Planning and Land Use Department Planning Commission Staff Report

Case No: 2022 - 5393
Hearing Date: August 4, 2022
Applicant: MBR 7261 Airport Road LLC
Request: Development Plan Approval
Location: 7261 Airport Road
Case Mgr.: Daniel A Esquibel
Zoning: C-2 (General Commercial)
Overlay: Airport Road Overlay and River and Trails Archaeological Review Districts
Pre-app. Mtg.: February 10, 2021
ENN Mtg.: May 04, 2022
Proposal: Request Development Plan approval to construct a 221-unit multi-family apartment complex (which totals 261,000 square feet) on a 7.96-acre lot zoned C-2.

Case #2022-5393. 7261 Airport Road Development Plan. Orion-West LLC., Agent, MBR 7261 Airport Road LLC, Applicant (Buyer), Request Development Plan approval to construct 261,000 square feet of new construction for a 221-unit multi-family apartment complex. The project is a 7.96-acre lot zoned C-2 (General Commercial) within the Airport Road Overlay and River and Trails Archaeological Review District.

Figure 4 Bicycle Parking

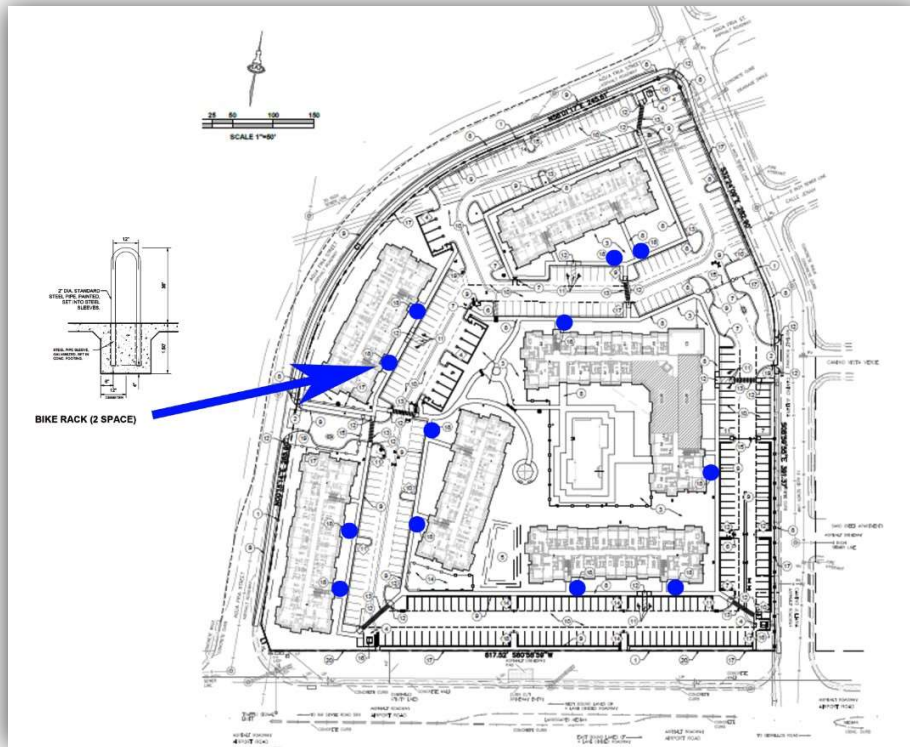
The applicant is providing 90° “One Size Fits All” parking. However, the plan includes “Small and Standard Cars” parking. This will be updated as part of the required technical corrections.

The compact car parking will need to be converted to “one size fits all” parking stalls as conditioned in Table 1 Conditions of Approval.

The Development Plan identifies twelve inverted U type bicycle racks proposed throughout the project (Reference Figure 4 “Bicycle Parking”). A total of 24 bicycle parking spaces are proposed for the project where 12 are required. The project exceeds both parking and bicycle parking numbers required in Chapter 14 Exhibit A - Table 14-8.6-1 “Parking and Loading Requirements” and Table 14-8.6-3 “General Off-Street Bicycle Parking.”

Figure 5 Traffic Study Area

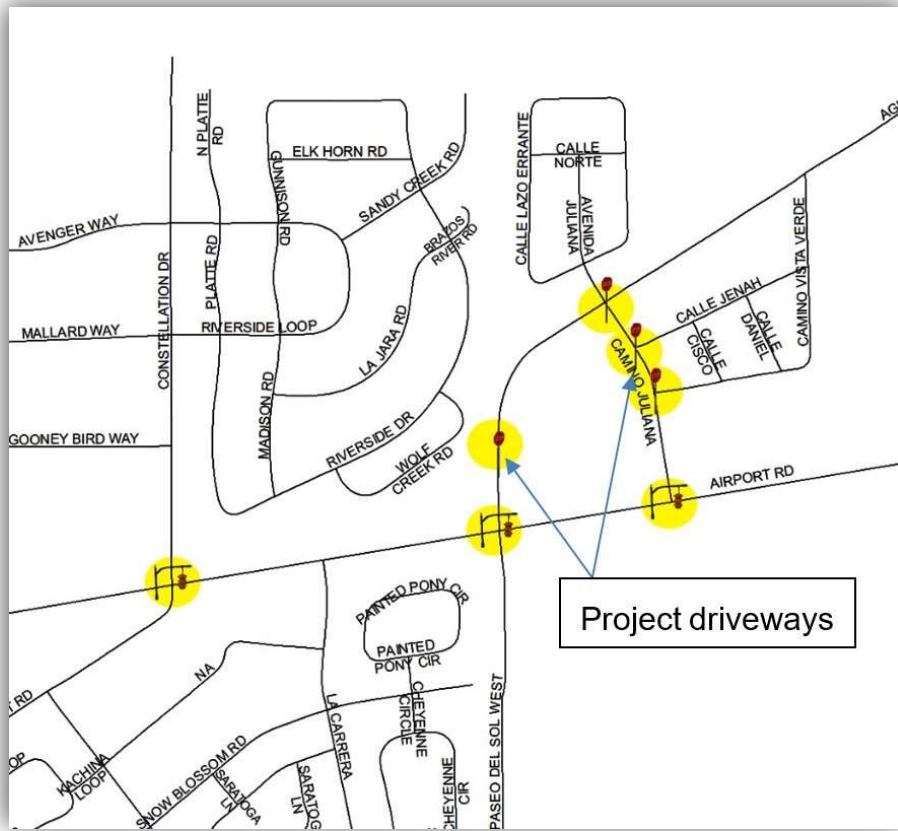
- i. General – add discussion on existing alternative modes of travel (transit/bicycle/pedestrian).*
- ii. Page 7, Table 2 and Table 3 – update AM and PM Peak headers from “2021” to “2022”*

- iii. Page 8, Figure 2 – Verify volumes at Agua Fria/Site Entrance with the Existing & Projected Turning Movements table in the appendix. The northbound and southbound movements are flipped.*

- iv. Page 9 – both the ITE Trip Generation Manual 10th and 11th editions are referenced. Reword sentence to only state the one that was used.*
- v. Page 17 – Based on the SAMM, if the right turn volume is greater than 56 vehicles per hour, a turn lane is warranted. At Airport/Camino Juliana intersection in the 2022 Existing Condition, there is 72 vehicles turning right in the PM peak and in the 2027 Build Condition, there is 93 vehicles turning right in the PM peak. Need to state in the TIA that a turn lane is already warranted in existing conditions without the proposed development and provide a justification on why the study indicates it is not warranted with the development.*

- vi. Plans – Verify that landscaping/fencing/signs are not within the sight triangles of vehicles exiting the development.*
- vii. Plans – Need a signing and striping plan.*

Figure 9 City Utilities

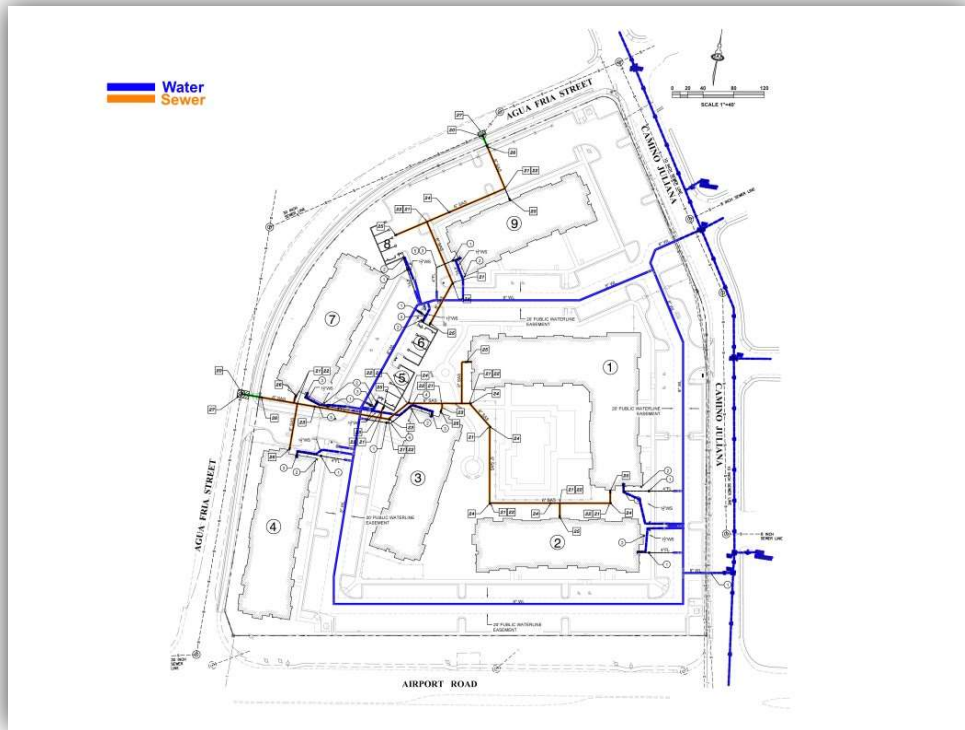
The proposed development will connect to city services for water and sewer. The project is connecting an 8” water line to a 12” water main off Camino Juliana, and sewer will connect to two points off Agua Fria Street (Reference Figure 9 “City Utilities”). Dry utilities were not addressed in the applicant’s plans.

The Applicant projected a water budget of 30.874-acre feet of water per year. The City Water Resources Division has not approved the water budget and has requested additional information. Four conditions are included in Table 1 “Conditions of Approval” and on technical correction listed in Exhibit A “Technical Corrections.”

Figure 10 Fire Hydrants

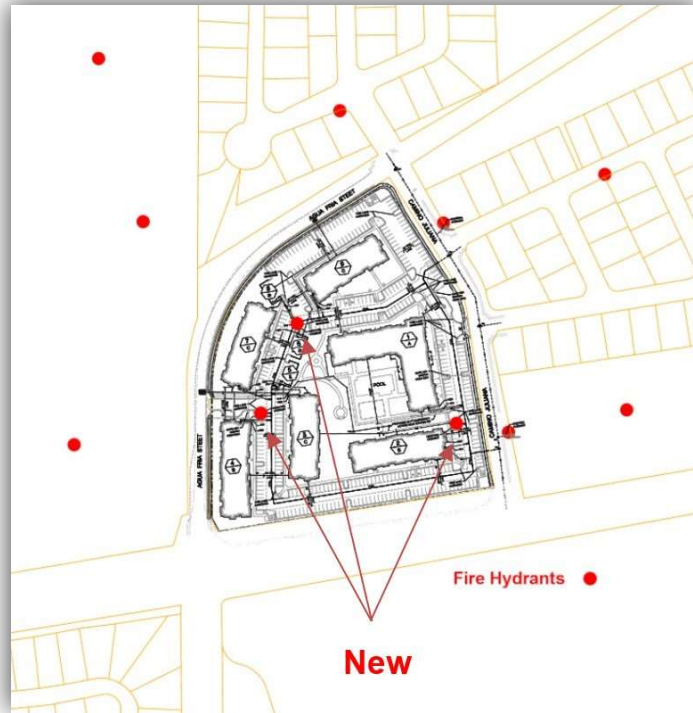
There are two existing fire hydrants located off Camino Juliana. The Applicant’s plans include 3 new fire hydrants, sprinklered buildings and fire lanes. Entrance gates will be fitted with Knox key switches.

The Fire Marshal has provided standard comments, which can be found in Exhibits A and B.
